ADDENDUM NO. 1

PROJECT TITLE: EROSION REPAIR-  
FOREST PARK NATURE CENTER  
@ HIGH POINT TERRACE

ISSUANCE DATE: 9/27/16

LOCATION: Forest Park Nature Center

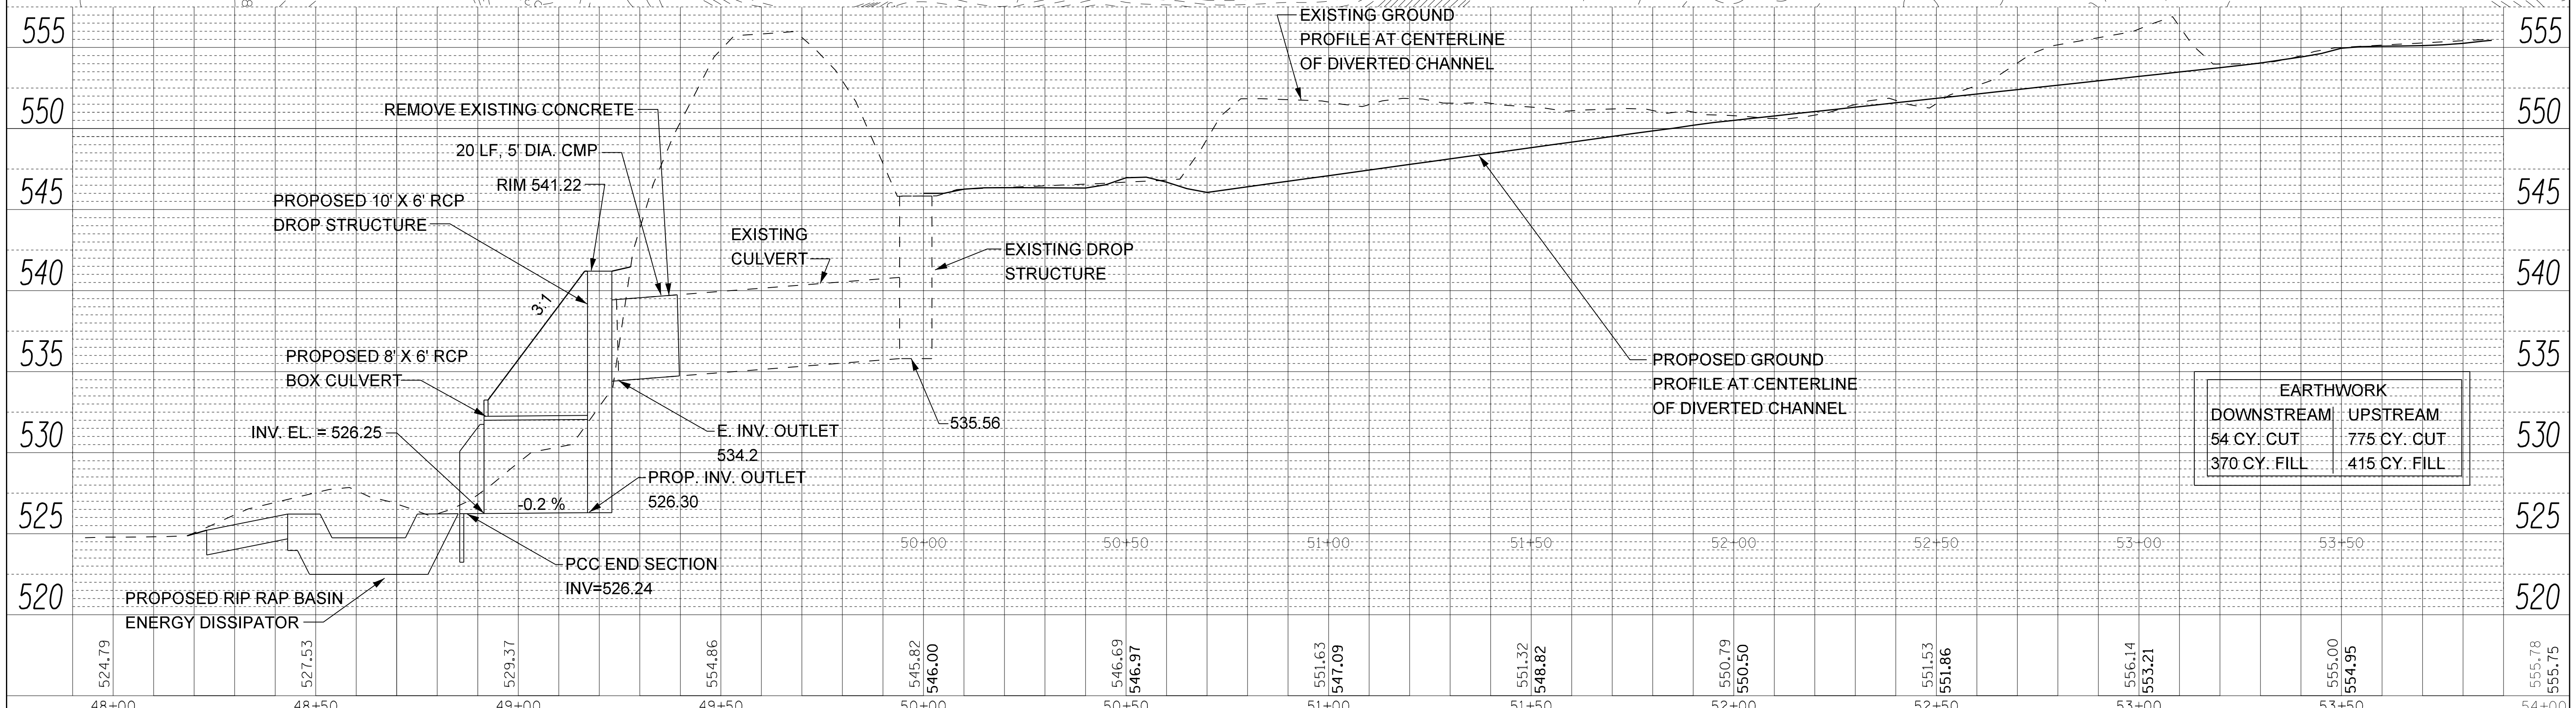
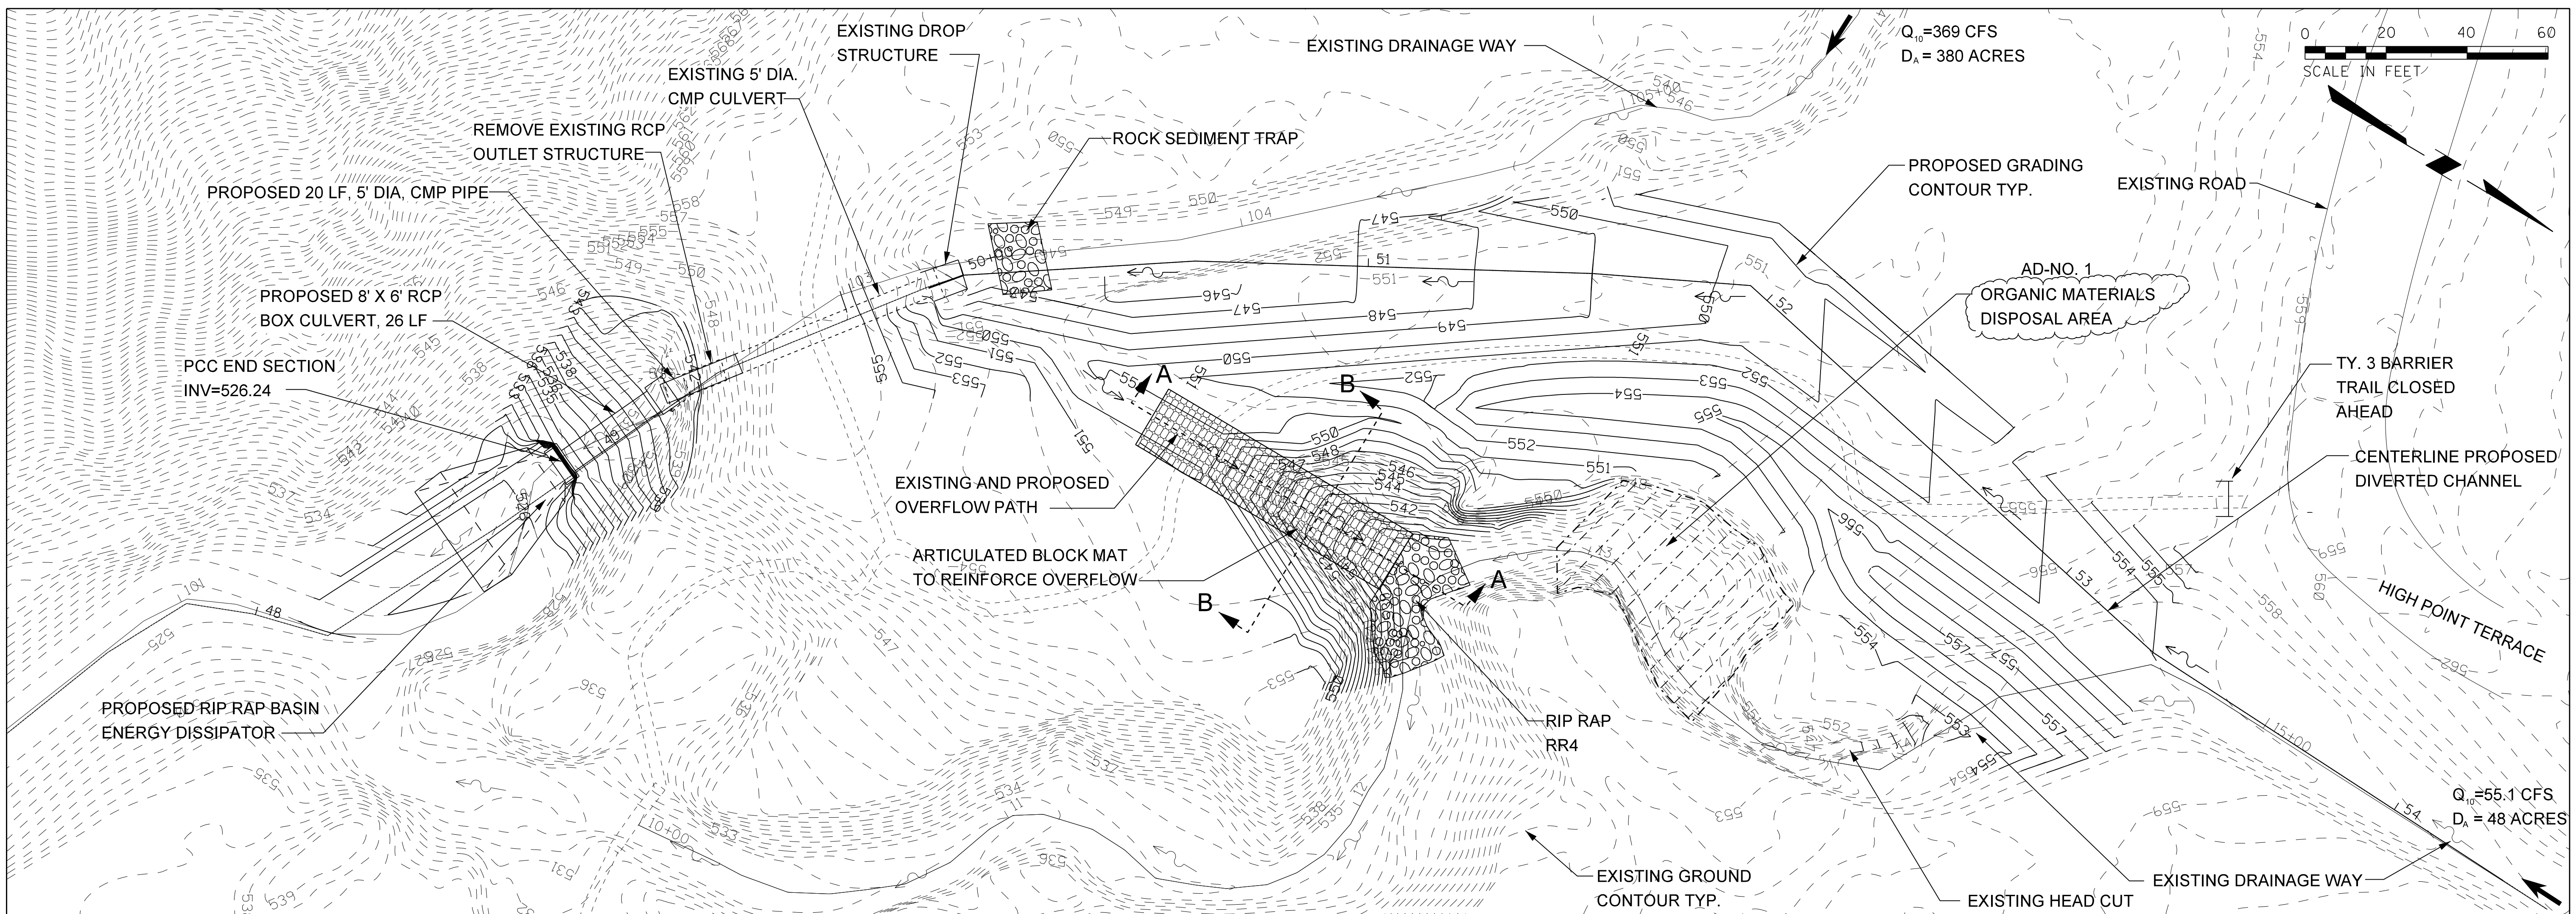
1. Section 202.03 of the Standard Specifications: Removal and Disposal of Surplus, Unstable, Unsuitable and Organic Materials is applicable and shall be amended to include: Chipped organic materials may remain on site and be filled in the area designated "Organic Materials Disposal Area" on the attached plan. Stumps may also remain on site and be placed in the area marked on the attached plan. The Park District does have another site available for stump disposal near Detweiller Park should the area marked on the attached plan not be sufficient.
2. Clarification: The quantity for Articulated Concrete Block Mat indicated on sheet C2 is only for the exposed surface area, it does NOT include the buried perimeter toe-ins.
